STAFF REPORT

AGENDA ITEM TITLE: Sherman Hotel Major Certificate of Approval – 121 G Street

REQUEST: The request is to receive a Certificate of Approval on the following external work that is being proposed for the Sherman Hotel.

Elongate 3 window openings to replace the windows with doors.

PLAN

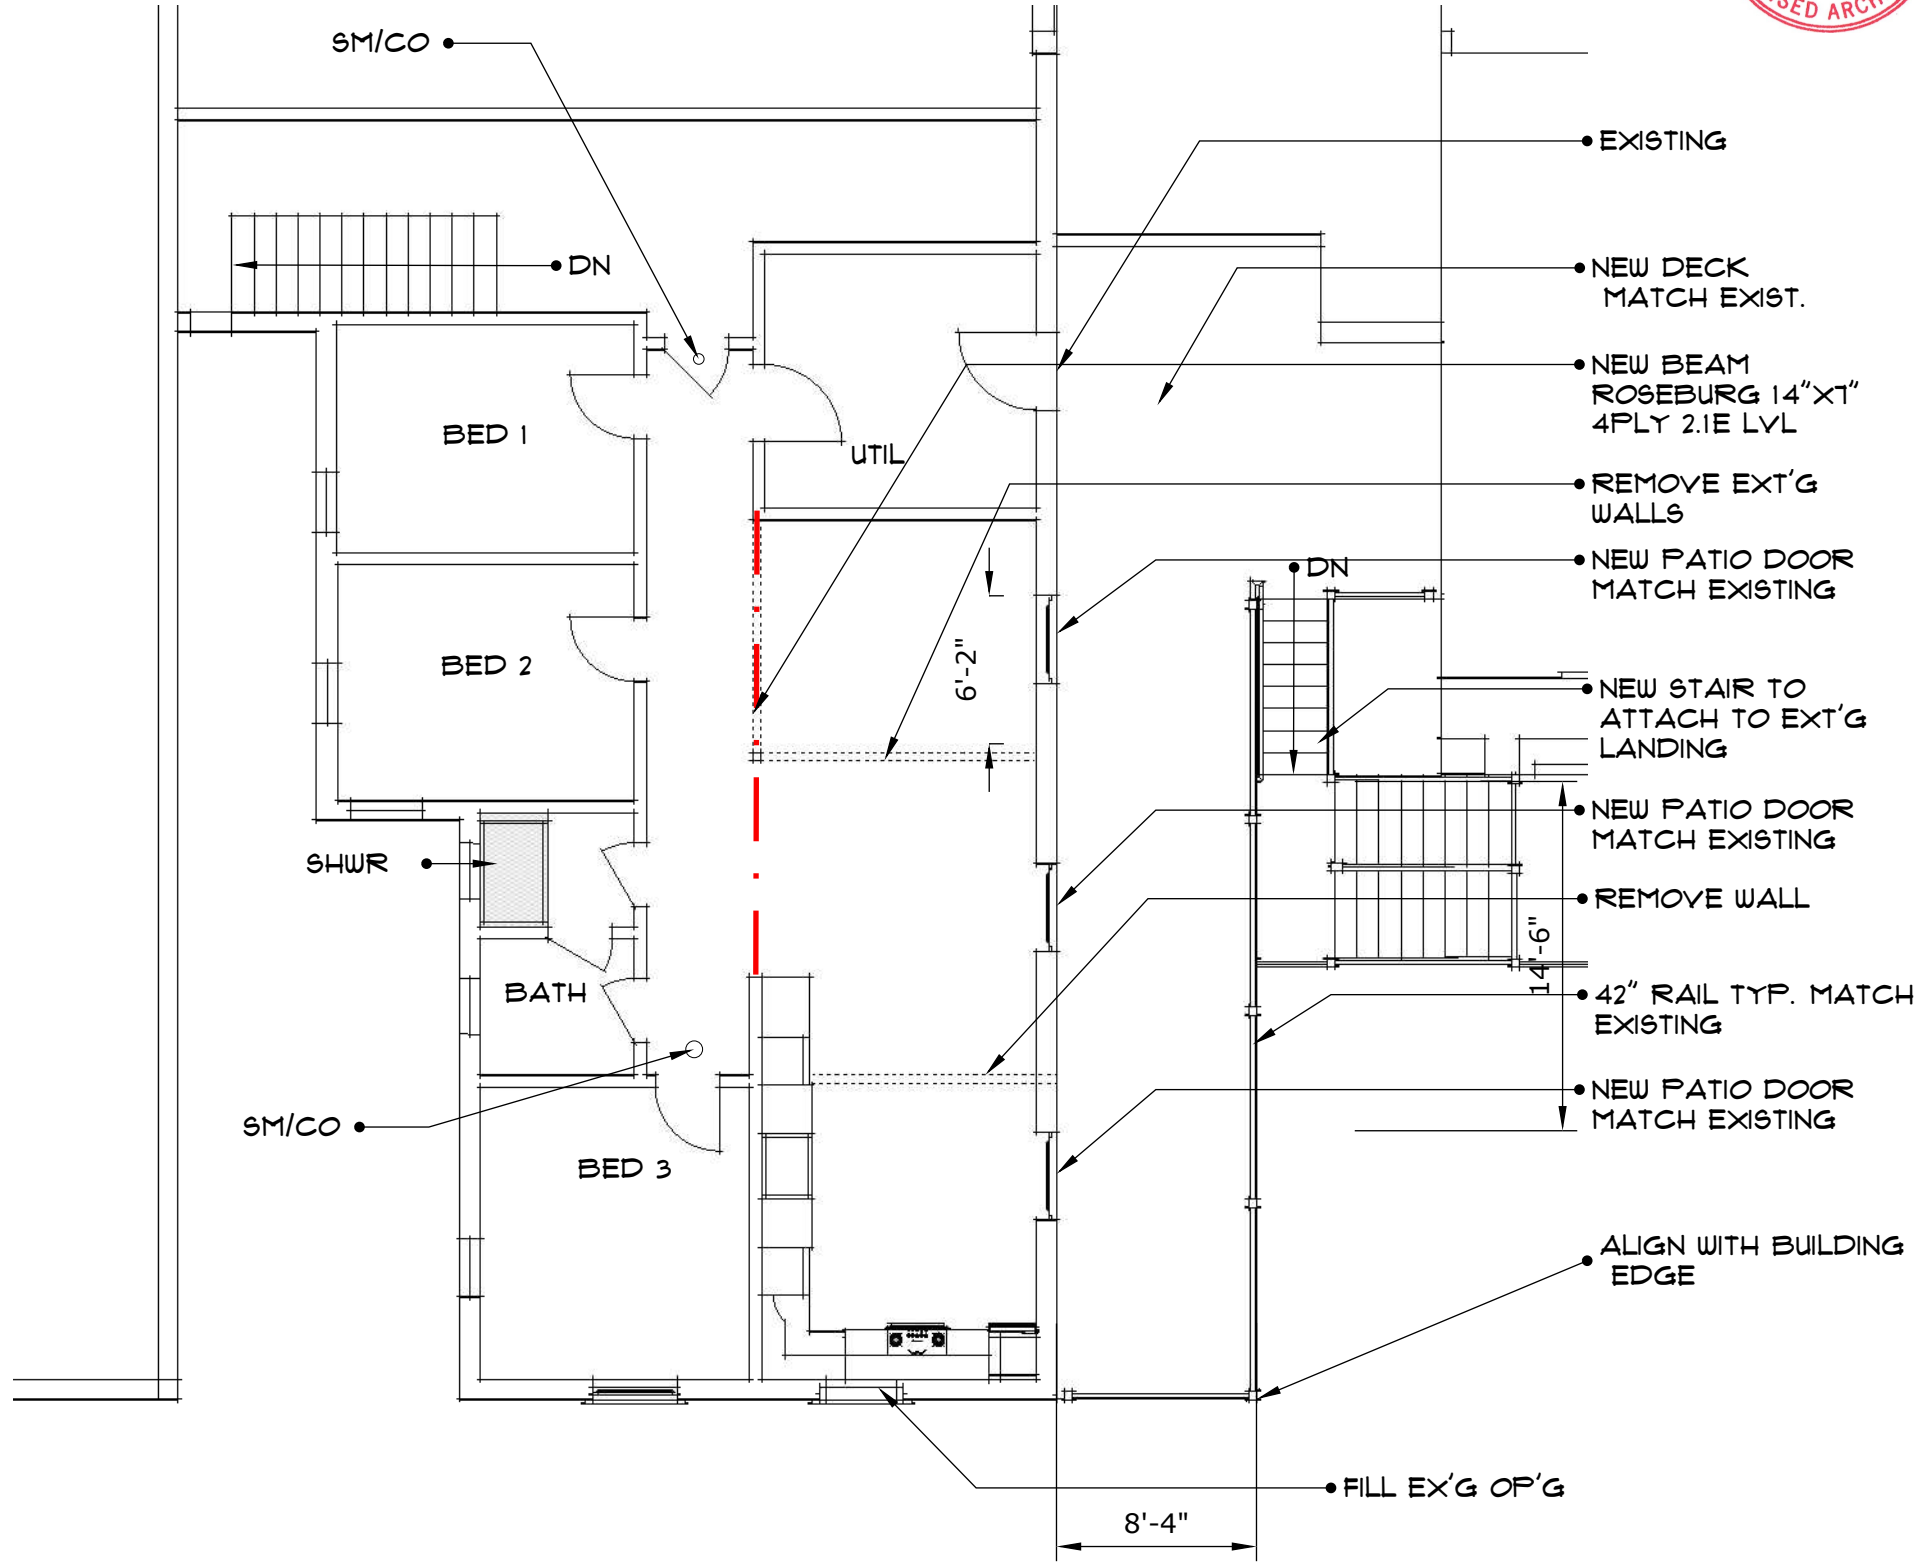
- The applicant is proposing to elongate three existing windows to create exterior door openings that would open out onto a previously approved balcony. According to Part 3, Section C of the Salida Design Guidelines; making a window opening into a door opening is preferable to installing a new door opening.

similar appearance to the original door. The proposal is to match the doors that were previously approved at this site and are currently being utilized as the second floor balcony doors facing this same courtyard from the 151 First Street Building. This is a photo of the current and proposed door:

The HPC recommended this modification to minimize the amount of change requested from the first request (which was to expand the openings horizontally as well as vertically).

preserving the width of the horizontal openings and only extending them vertically to accommodate doors.

1. That the Commission **APPROVE** elongating three window openings to accommodate doors that match the existing 2nd floor balcony doors on 151 West First Street.
